**Technical Note
e-Notification**

No. 02
August 30, 2019

Technical Note 02

Figure 1 – Sample BrR Structure Typical Section (H10 – 26’)

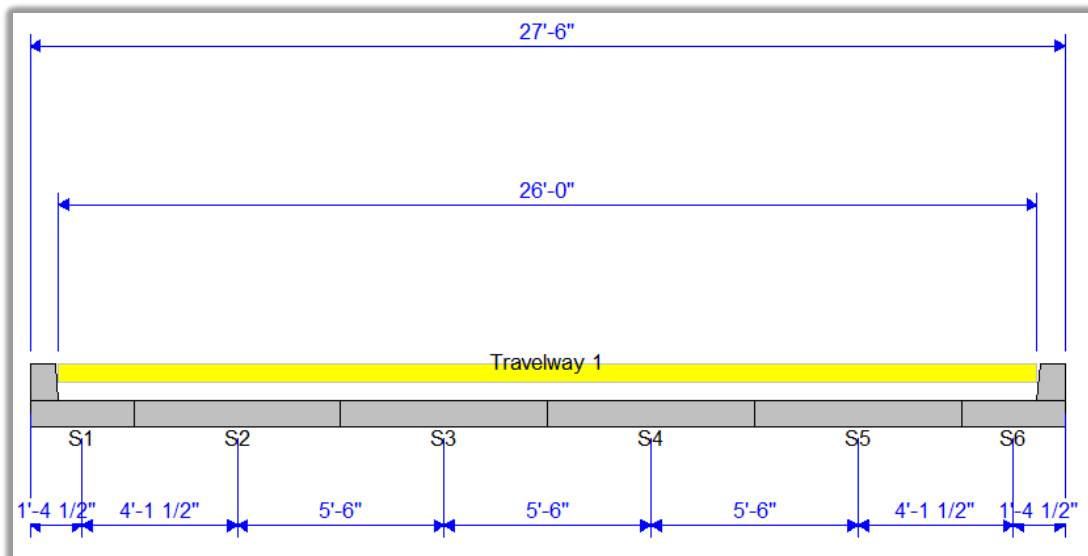
For this contract, all standard precast slab bridges shall be modeled and rated in BrR using a *Reinforced Concrete Slab System Superstructure* definition, with each individual slab strip width input to match the precast units as shown in the standard drawings. See a sample BrR Structure Typical Section in *Figure 1* below.

Figure 2 – 5'-6" Interior Slab

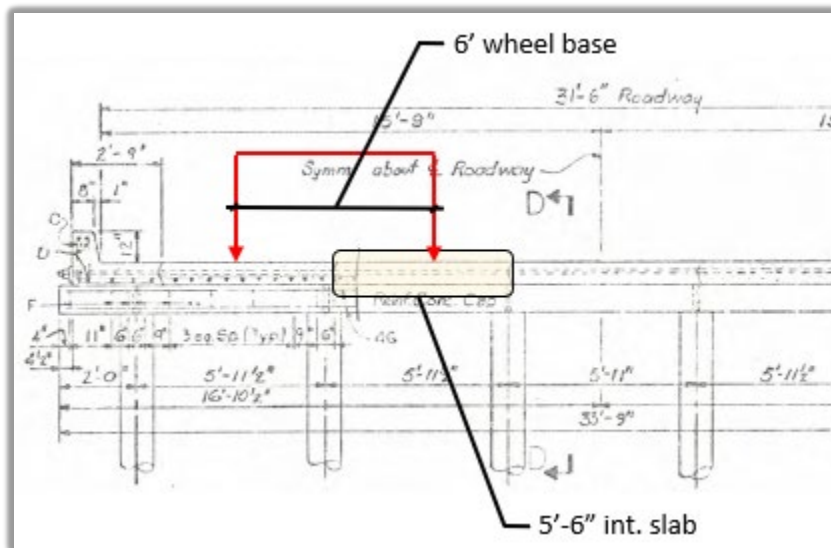
| See Figure 2 | See Figure 3 | See Figure 4 |

| <u>Interior Slab units:</u> | <u>2'-9" Exterior Slab units</u> | <u>5'-6" Exterior Slab units</u> |
| LRFR = 0.6 lanes ² | LRFR = 0.0 lanes ¹ | LRFR = 0.6 lanes ² |
| LFR = 1.0 wheels | LFR = 0.0 wheels ¹ | LFR = 1.0 wheels |

Figure 3 – 2'-9" Exterior Slab

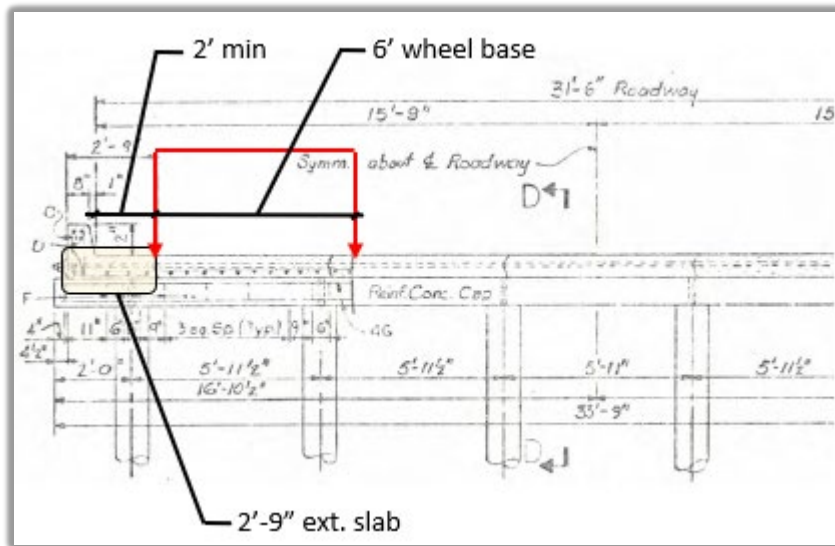
Live load distribution factors shall be computed by the lever rule. Live load on the exterior slab units shall be determined in accordance with AASHTO LRFD Section 3.6.1.3.1. Generally, the 2'-9" exterior slab units are cast with a 9" curb and therefore the edge wheel line is not supported by the slab. The 5'-6" exterior slabs can generally accommodate a single edge wheel line.

Note 1: to prevent run-time errors in BrR, input a LLDF of 0.001 (LFR and LRFR) for the exterior units which do not carry live load

Figure 3

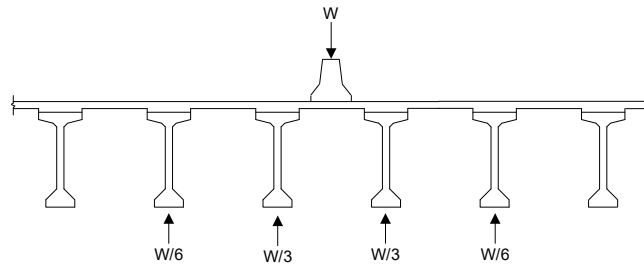
If there is a longitudinal joint in the median (and no diaphragms in the bay under the median), then the portion of the median on each side of the longitudinal joint would be considered as the exterior SDL for that cross section of deck, and distributed as described above. If there is no longitudinal joint in the median, the BDM does not discuss SDL distribution for the median. Using the same logic as that provided for the exterior SDL (sidewalk etc.) would imply that median SDL should also be distributed to multiple girders under and near the median. Therefore, we would interpret that intent as follows:

1. For a median centered over a girder, median SDL should be distributed to that girder and the two girders on either side (3 girders total).
2. For a median over a girder bay between 2 girders, median SDL should be distributed to the two girders on either side of the bay and one girder adjacent to each side of that bay (4 girders total).

We agree with this approach, as we have illustrated in Figure 3 of the simple sketch below:

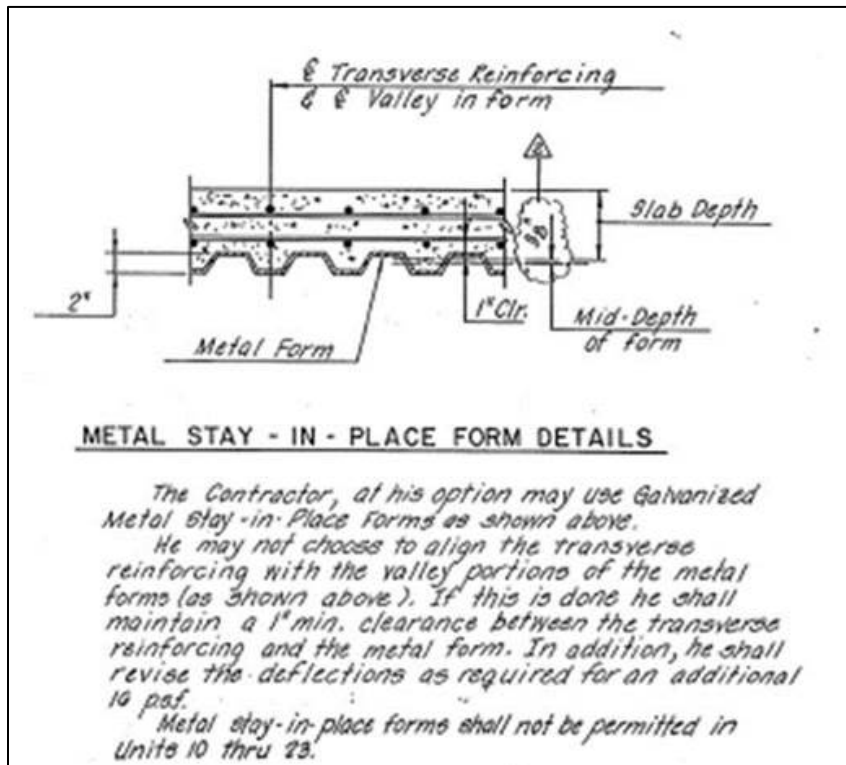
Typically shop drawings only show steel superstructure so there will not be any details of the deck/SIP forms on shop drawings. As far as the SA, the deck thickness in inner bays with SIP forms is not one of the items routinely measured. So, the design plan details of the deck design thickness relative to the SIP forms (such as shown below) is the only information that can be used to make modifications to the load in case the bridge requires posting. Also, in most cases, the SA will be completed by the time final rating results are received. So, in a case like shown below, if the bridge needs posting, the SIP weight would be changed to the weight of 3/8" additional thickness of deck (5 psf). If the detail shows the bottom of the slab at the mid depth, then the SIP weight would be zero.

Please verify that the above approach using design plan details is reasonable in case the standard 16 psf results in a need for posting.

The SIP detail shown above mentions another option for the Contractor to use for installation of the SIP forms. As you mentioned, this will be difficult to confirm in the field. To be conservative and follow the plan note and LRGD use 16 psf for the weight of the additional concrete in the SIP forms and use deck thickness shown on the plans. If a bridge requires posting and during the posting avoidance process it is determined that removing the 16 psf increases the ratings enough to eliminate the need for posting, this can be submitted as a BMO posting avoidance request for approval. Please note justification will need to be provided to document removing the 16 psf load is warranted (i.e. something was observed in the field to confirm the method the Contractor used to place the SIPs).
